## City of Lewisville, TX

### Planning and Zoning Commission Regular Session Agenda

**TO:** Planning and Zoning Commission  
**FROM:** Michele Berry, Planning Manager  
**DATE:** June 2, 2020  
**SUBJECT:** **Preliminary Plat of Heritage Towers Addition; Lots 1X, 2X, 3 and 4X, Block A; on 22.33 Acres out of the Steven Riggs Survey, Abstract Number 1088; Zoned Planned Development – Mixed Use (PD-MU) District; Located on the West Side of Summit Avenue Approximately 1,000 Feet South of Justin Road (F.M. 407), Being a Replat of Lot 2, Block B, Lewisville Corporate Center Addition.**

**PRELIMINARY PLAT FOR HERITAGE TOWERS ADDITION**

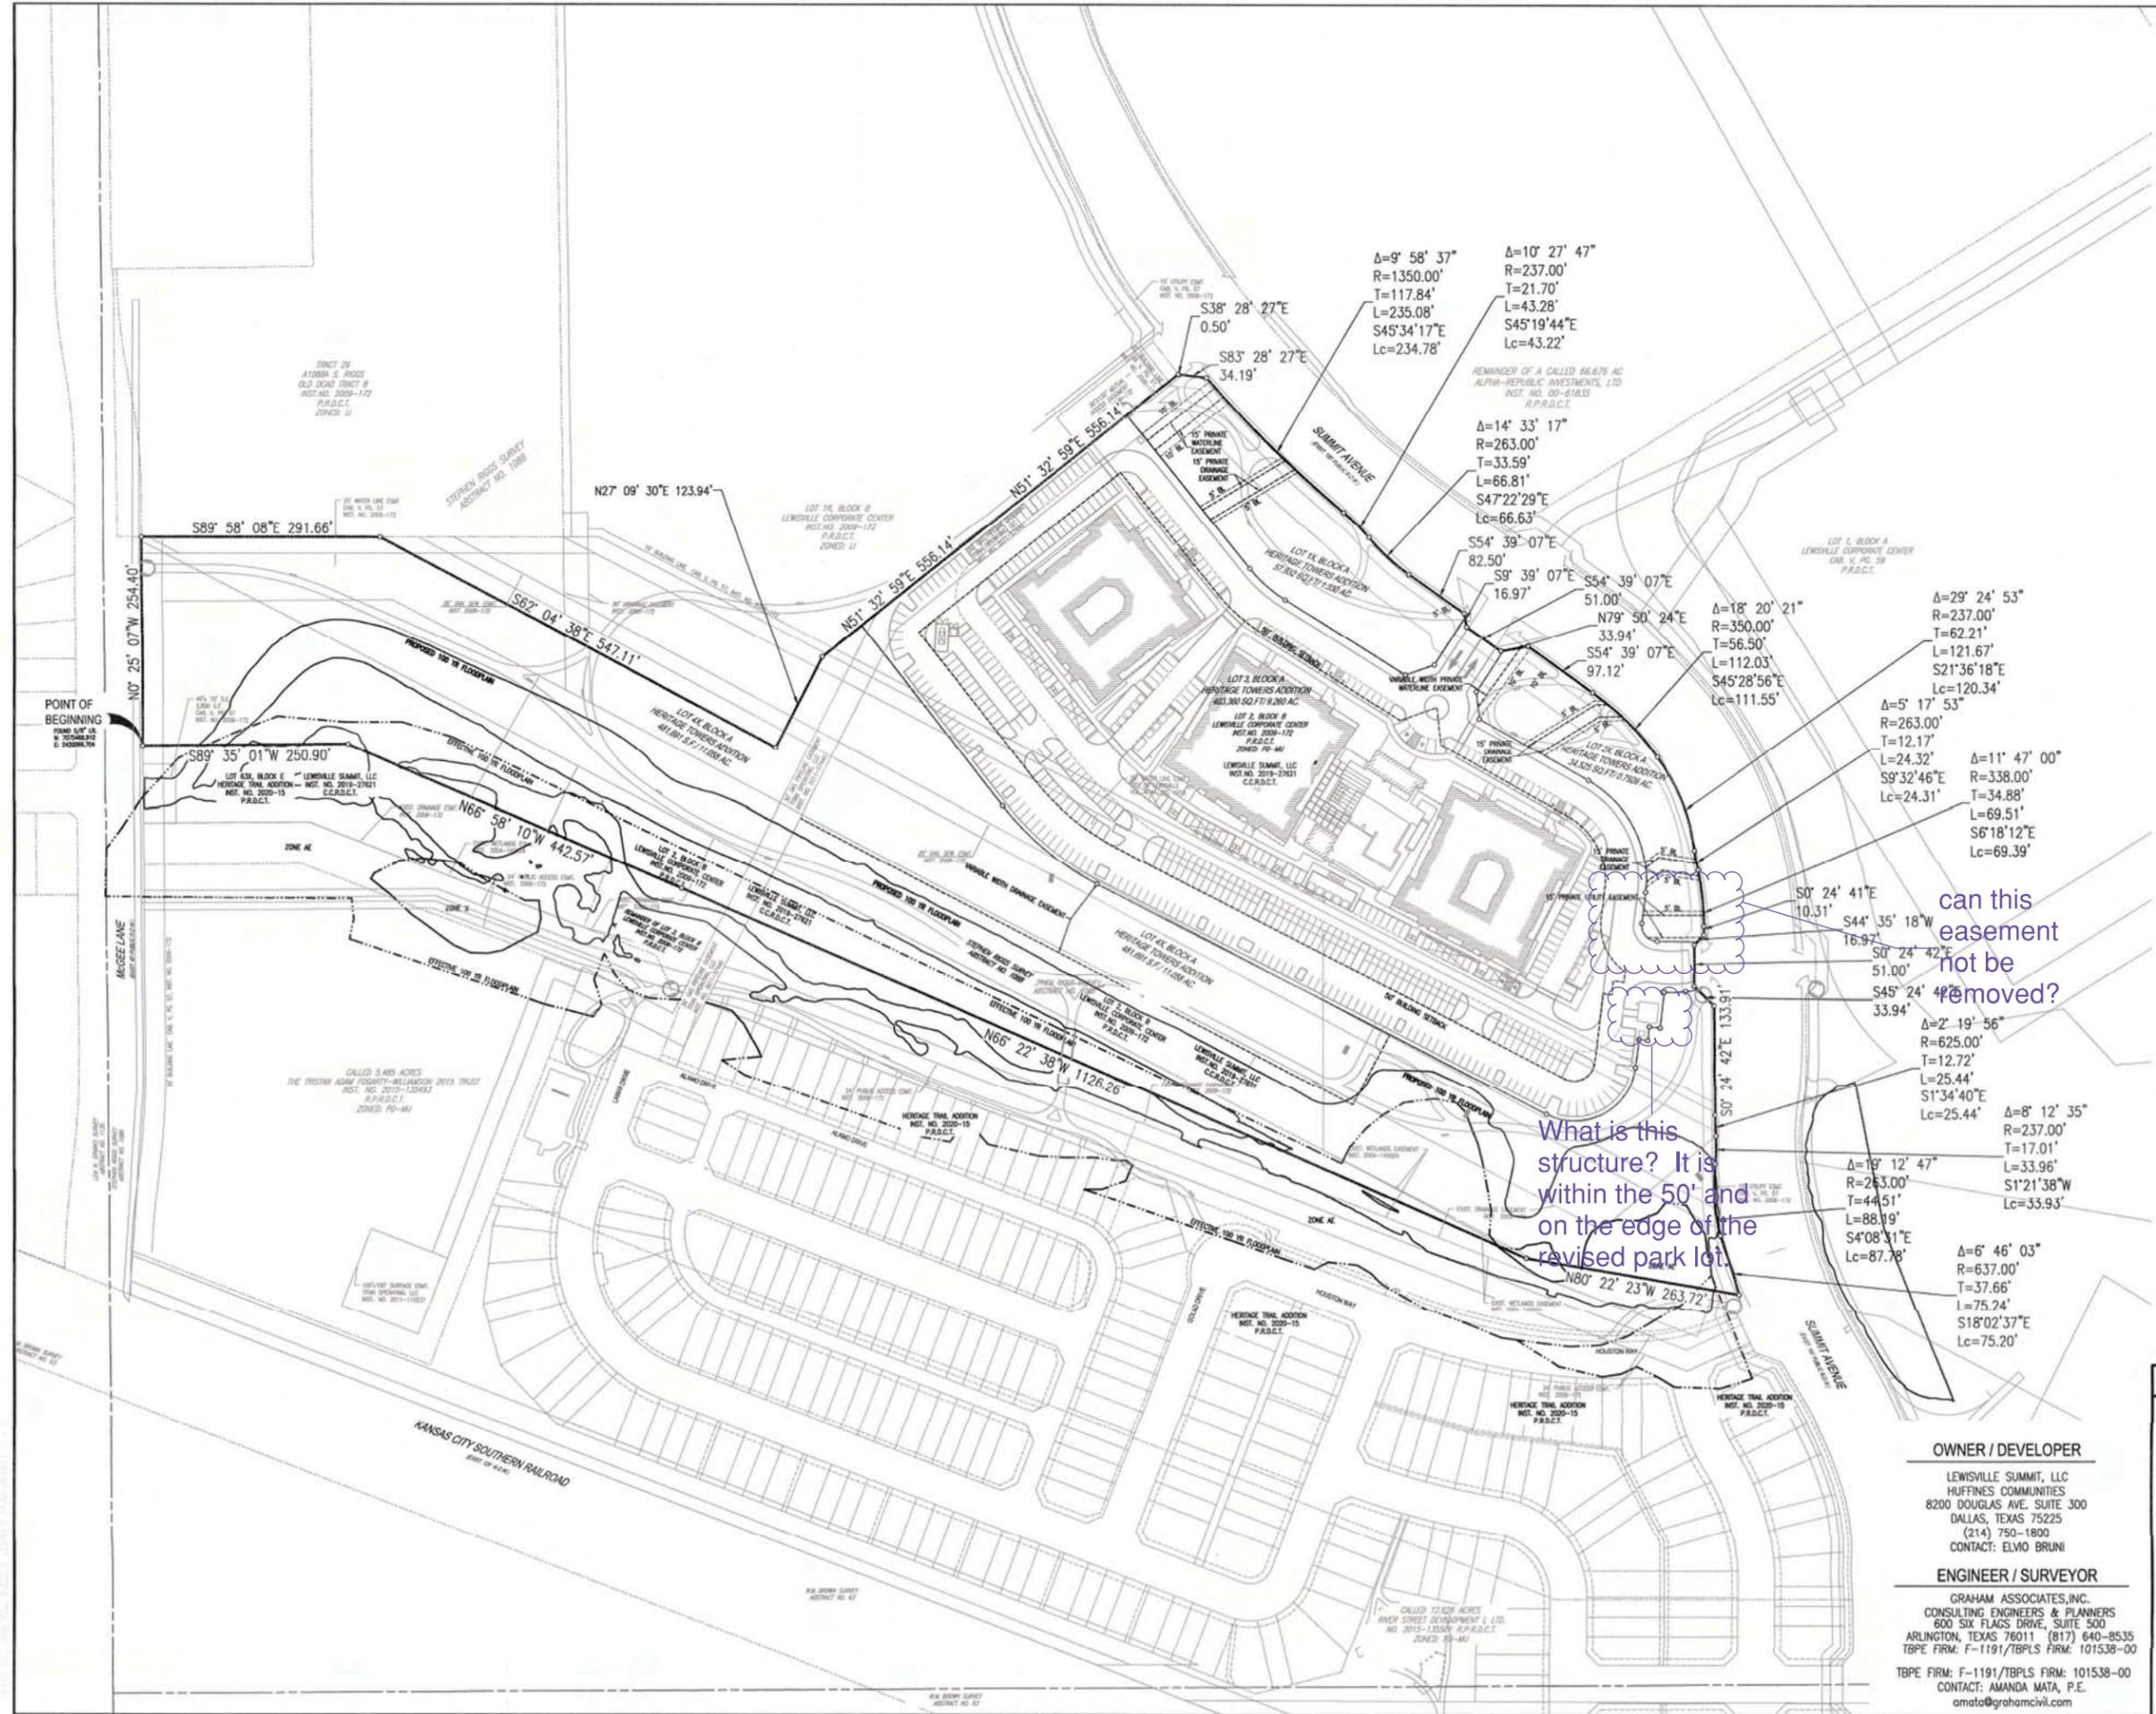
use language from appendix, below  
You have it correct on subsequent pages

What is this structure? It is within the 50' and on the edge of the revised park lot.

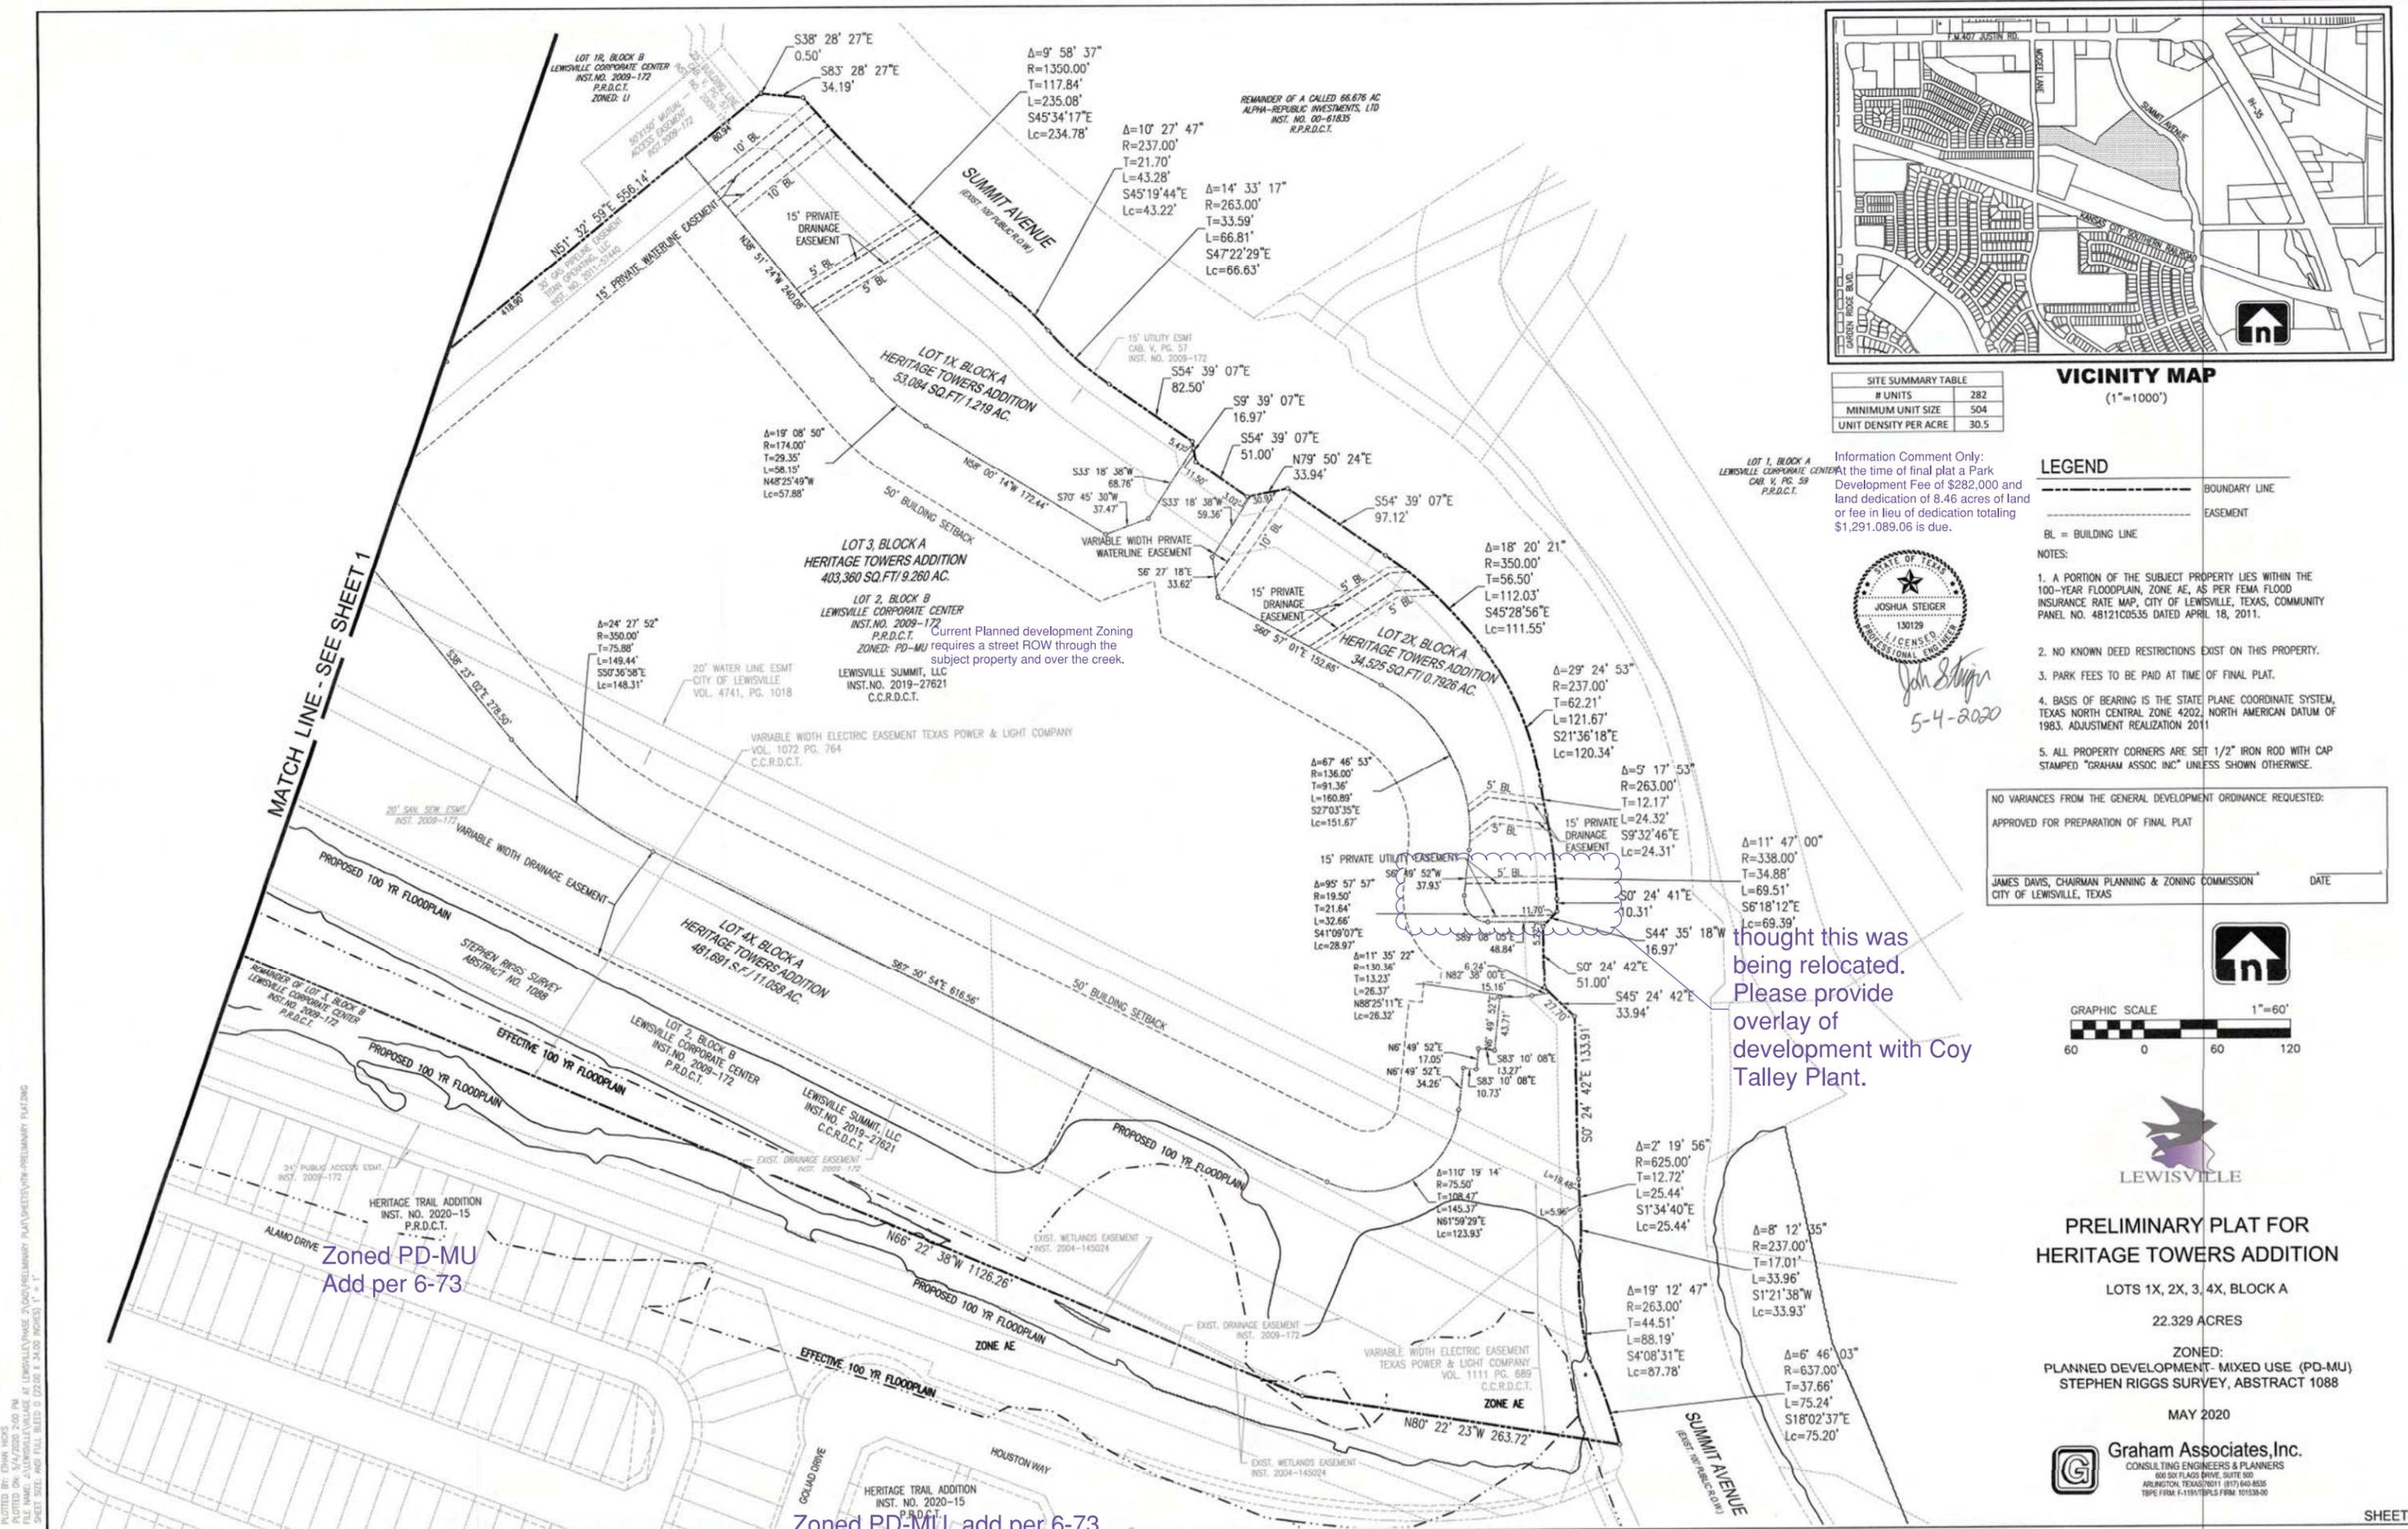
Zoned PD-MU  
Add per 6-73

Zoned PD-MU, add per 6-73

thought this was  
being relocated.  
Please provide  
overlay of  
development with Coy  
Talley Plant.

**PRELIMINARY SITE PLAN**

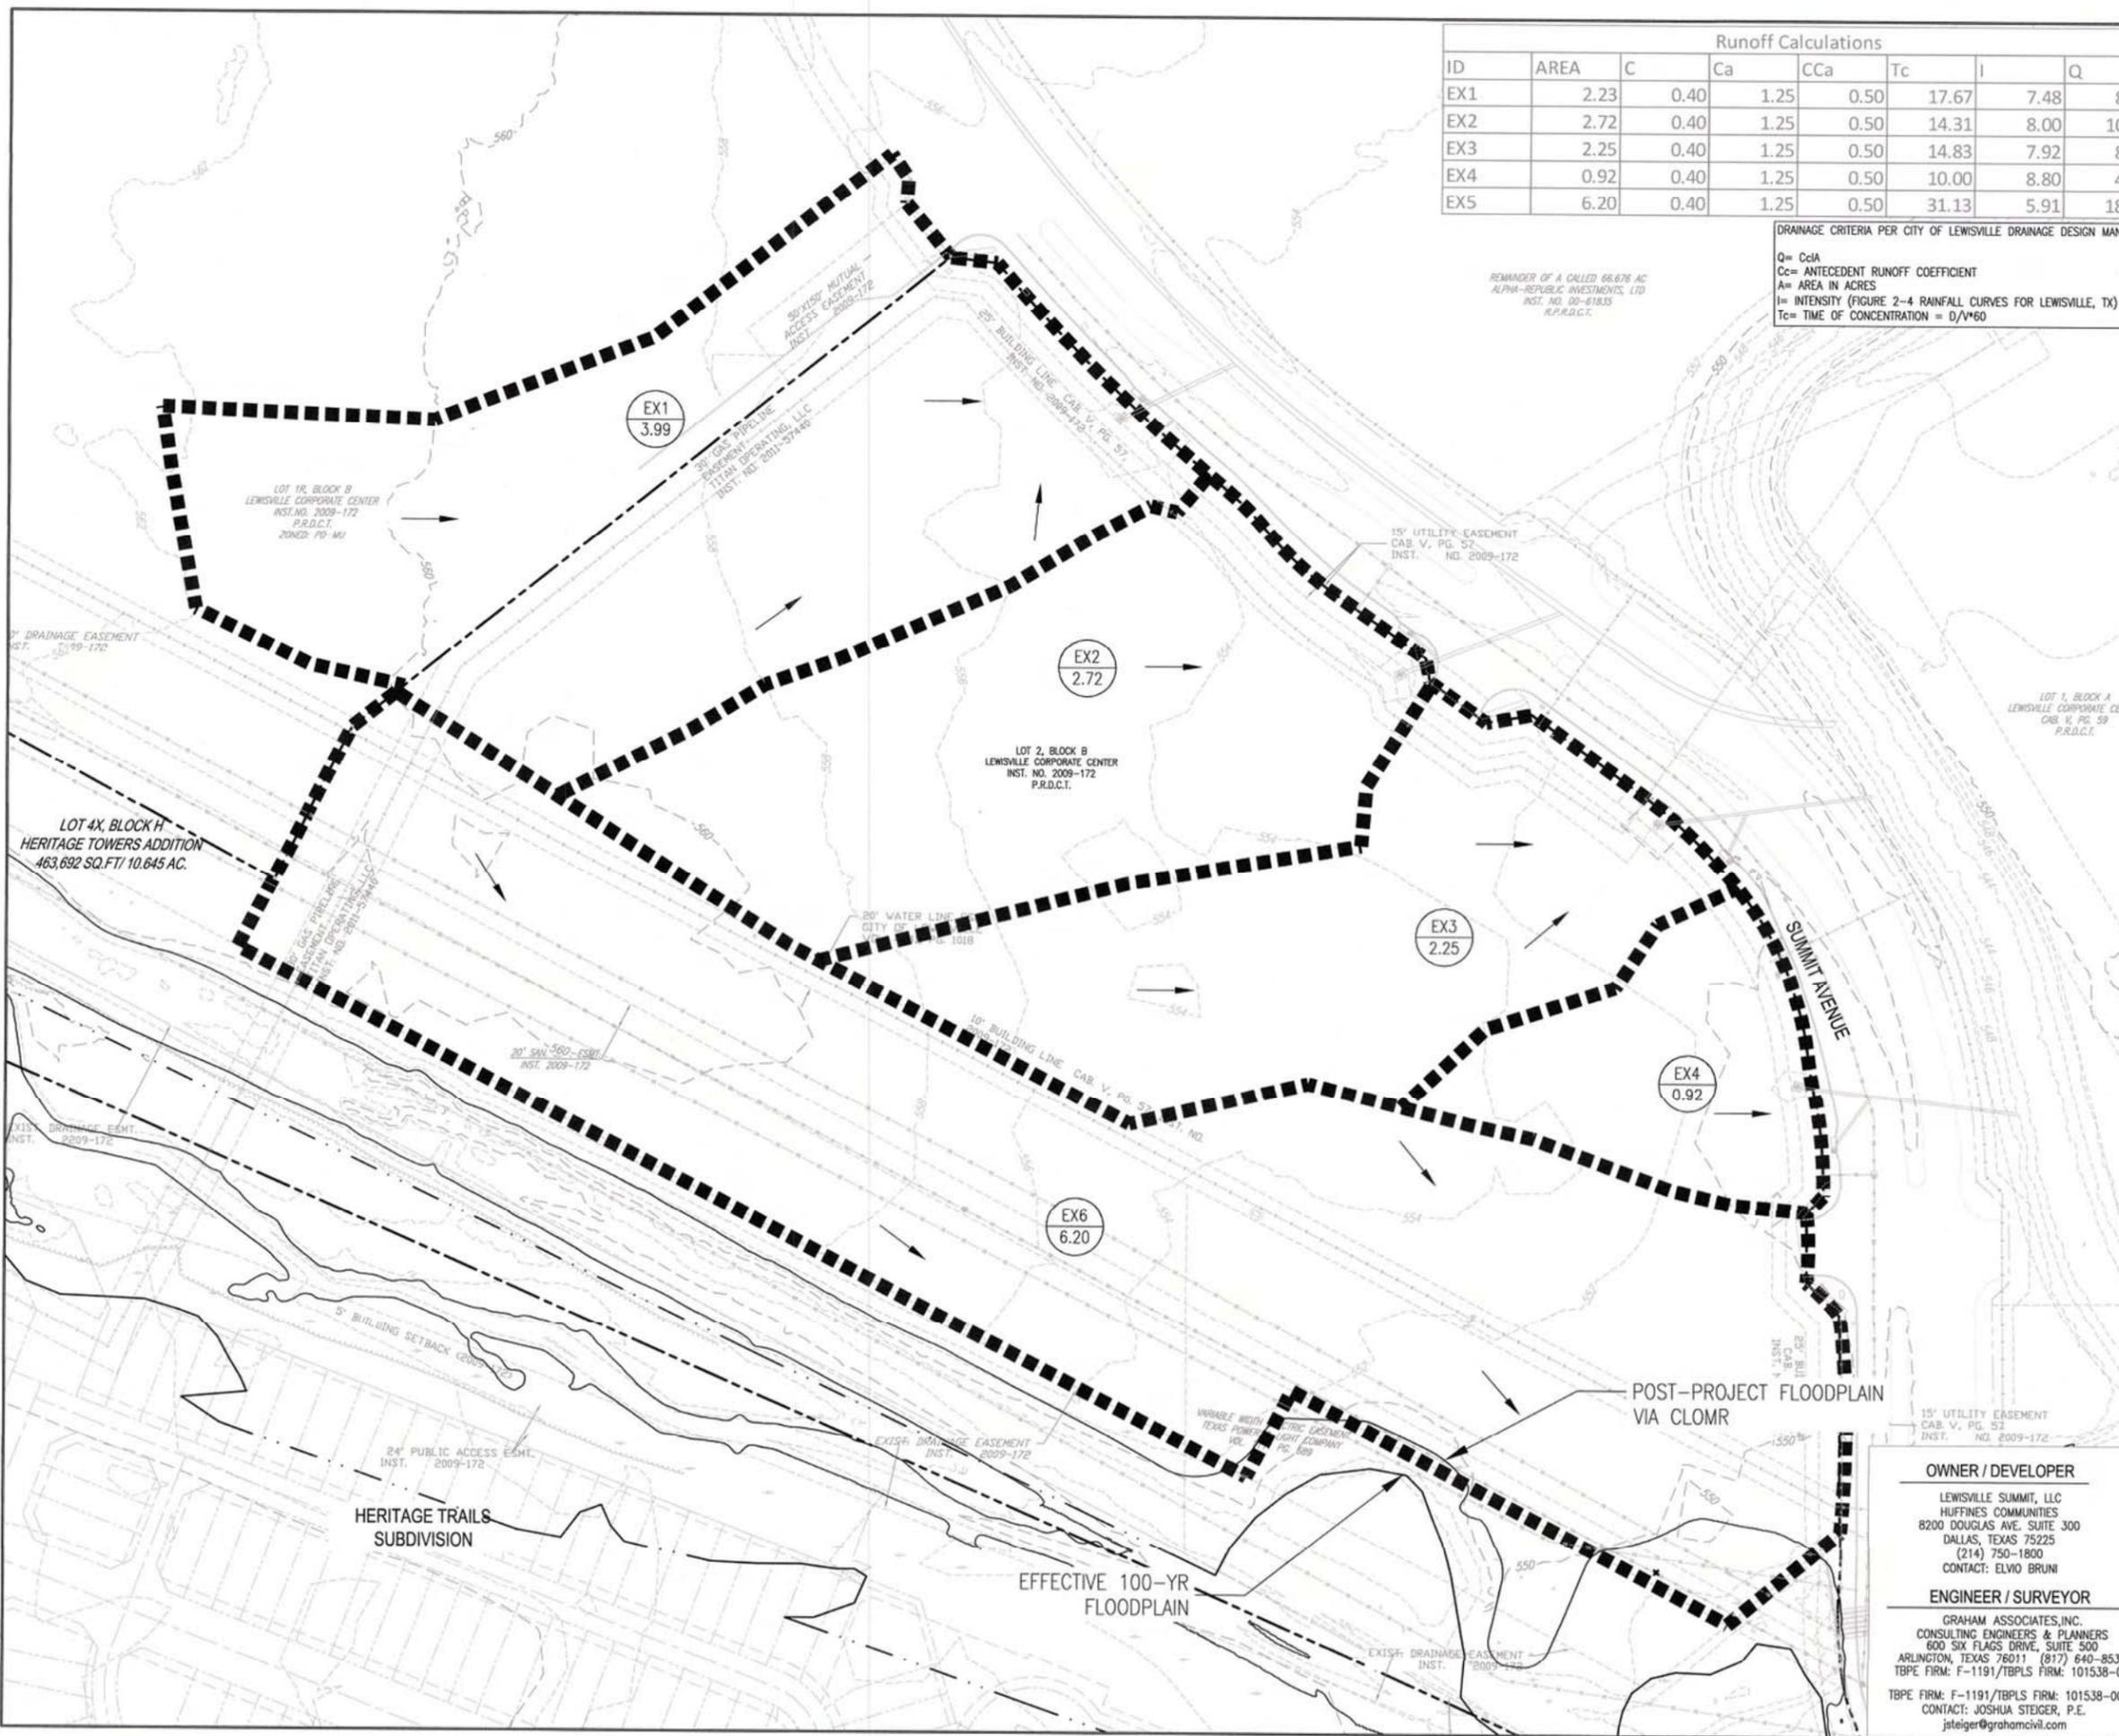
Parking not per current zoning Ordinance 04225-11-15. Zone change pending

Please provide overlay with Coy Talley Plan.

Site layout no conforming to current zoning Ordinance 04225-11-15. Zone change has been requested.

Please show detention area limits.
